| IEEE 802.1 REVISION REQUEST 0009 |

REQUESTED REVISION:
STANDARD: IEEE 802.1Q &/or IEEE 802.1AX
(possibly included into the 802.1AXbq (Distributed LAG)
specification/project)
CLAUSE NUMBER: Appropriate clauses for LinkLAG MIB and TLV
definitions such as P802.1Q-REV Annex D "D.2.7 Link
Aggregation TLV"
CLAUSE TITLE: Appropriate clauses for LinkLAG MIB and TLV
definitions such as P802.1Q-REV Annex D "D.2.7 Link
Aggregation TLV"

new-pelissier-laglldp-0110

Figure E.7—Link Aggregation TLV format

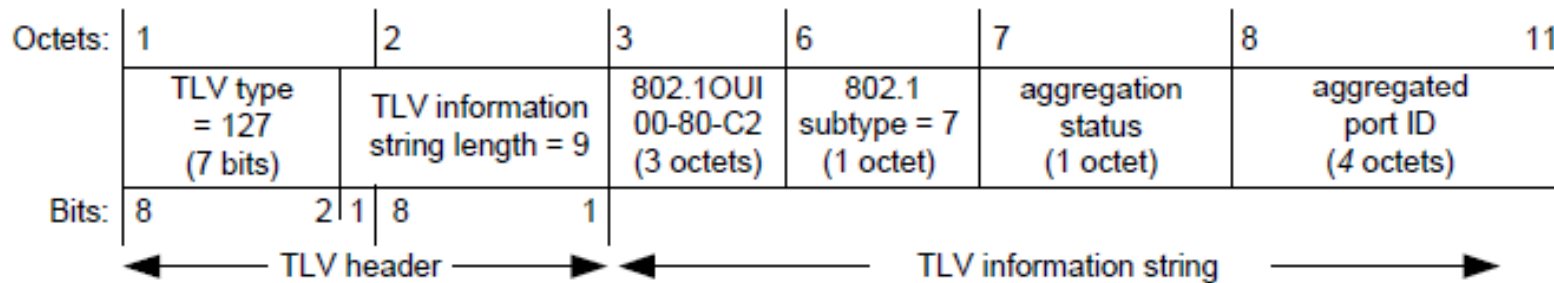
- Require LinkAgg TLV to be present if running in a Link Aggregation

- Will setting capable=0 and status=1 trigger error conditions within existing management stations?
- Aggregation portID can not be the same as any physical portID for this to work.
- Chassis-ID+Port-ID must be unique for each agent to be identified. If the aggregate uses the same Chassis-ID+Port-ID the receiver will wipe-out previously received data.
- This proposal makes it impossible to aggregate an aggregation. This may be already true
- Adds LLDP to the long list of protocols that must be coordinated in the implementations of Link Aggregations split across multiple chassis.

- Agents on physical links
 - Aggregation capability = 1
 - Aggregation status = 1
 - Aggregated PortID = PortID of aggregated link
 - PortID TLV = physical link PortID
- Agents on aggregates
 - Aggregation capability = 0
 - Aggregation status = 1
 - Aggregated PortID = PortID of aggregated link
 - PortID TLV = aggregated link PortID
